Addendum # 1

RFQ 1050

Lifting Bulls Creek Eastbound Structure

The following correction shall be considered as Addendum # 1 to this contract. The intent of this addendum is to clarify the required traffic control and the bearing pad restraint design.

Drawing 02 of 02 Jacking Procedure

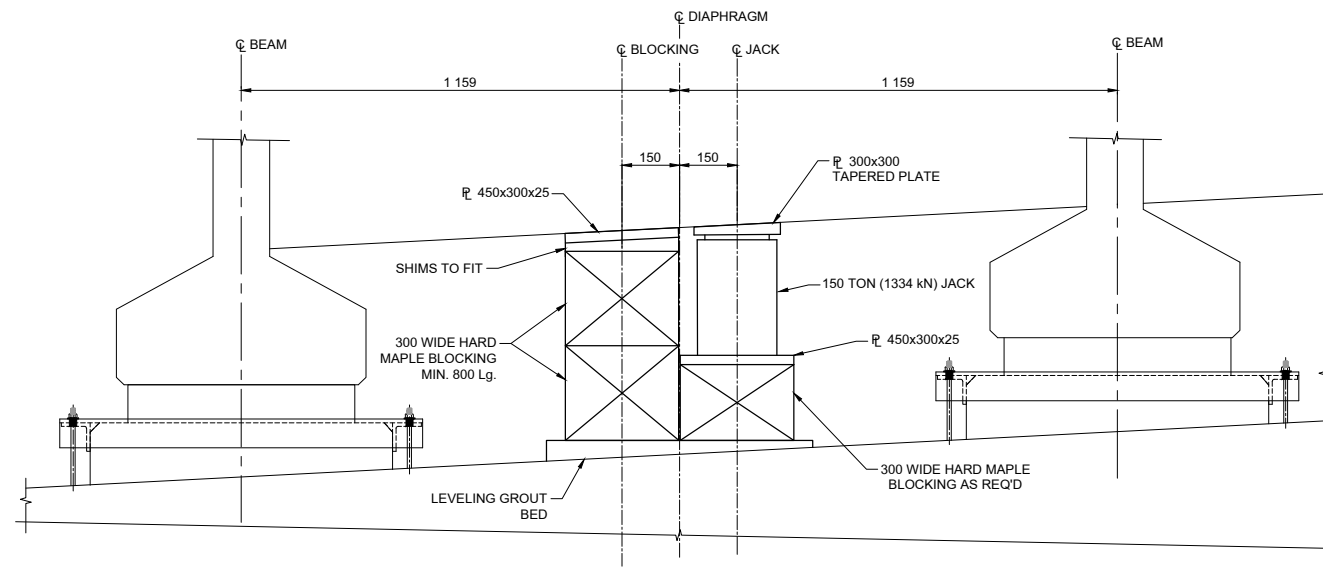
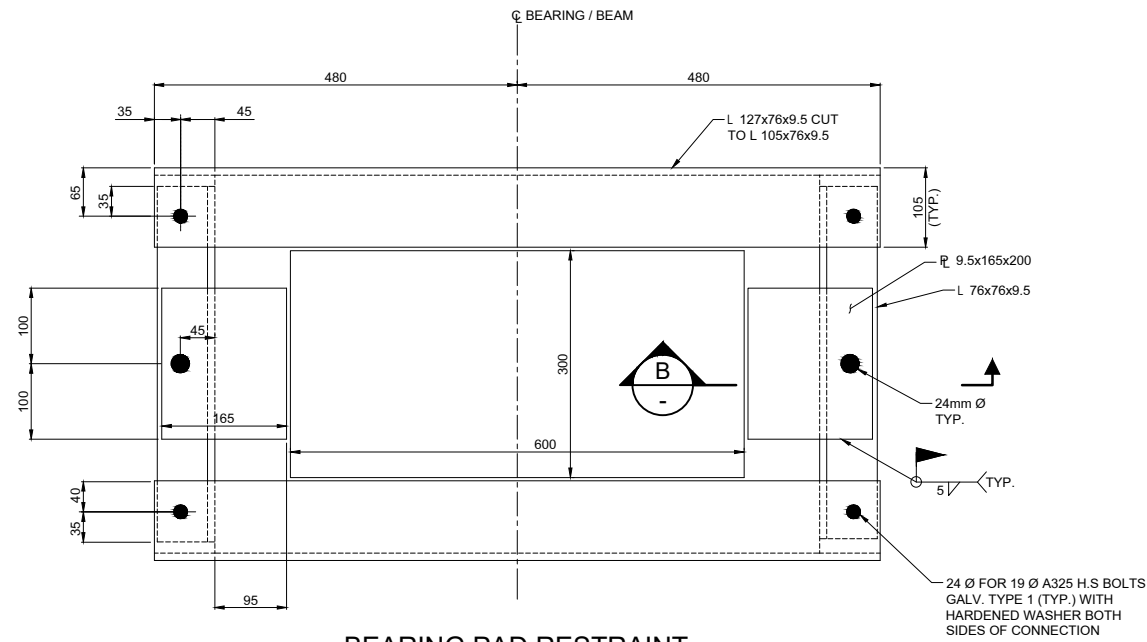
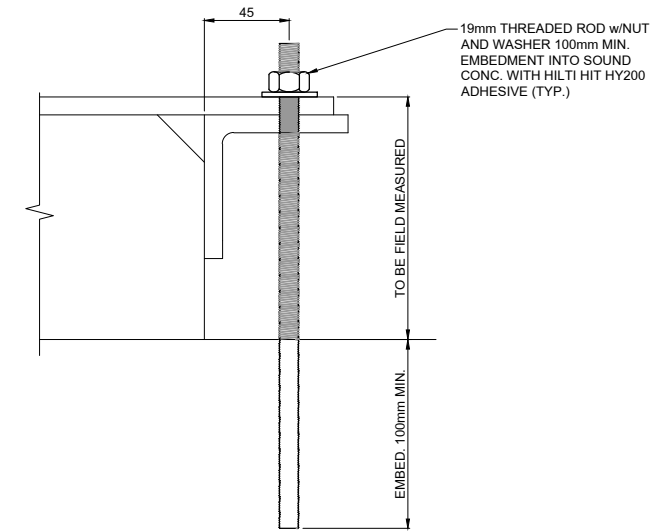
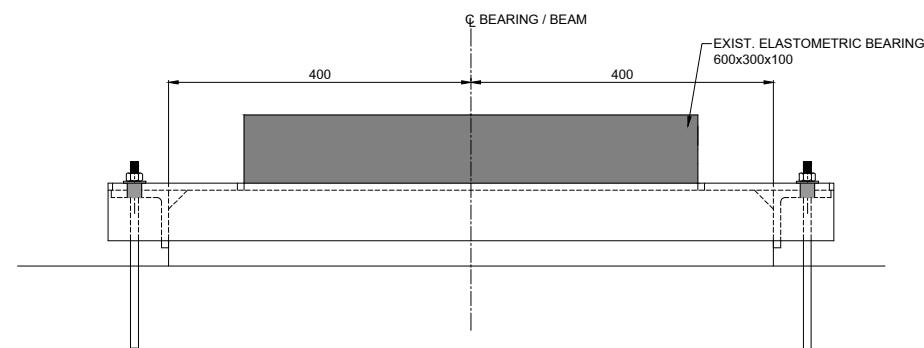
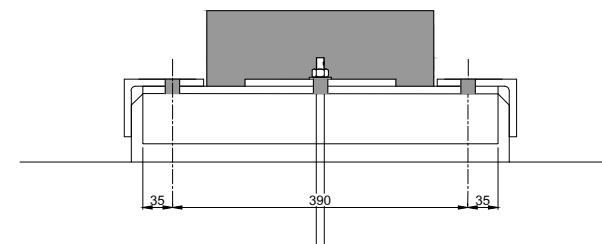
Bulls Creek EB Jacking Procedure
REPLACE:

REVISION DESCRIPTION	DATE
MODIFY FOR CLARITY	04-12-2019
ASSORTED CHANGES	03-19-2019
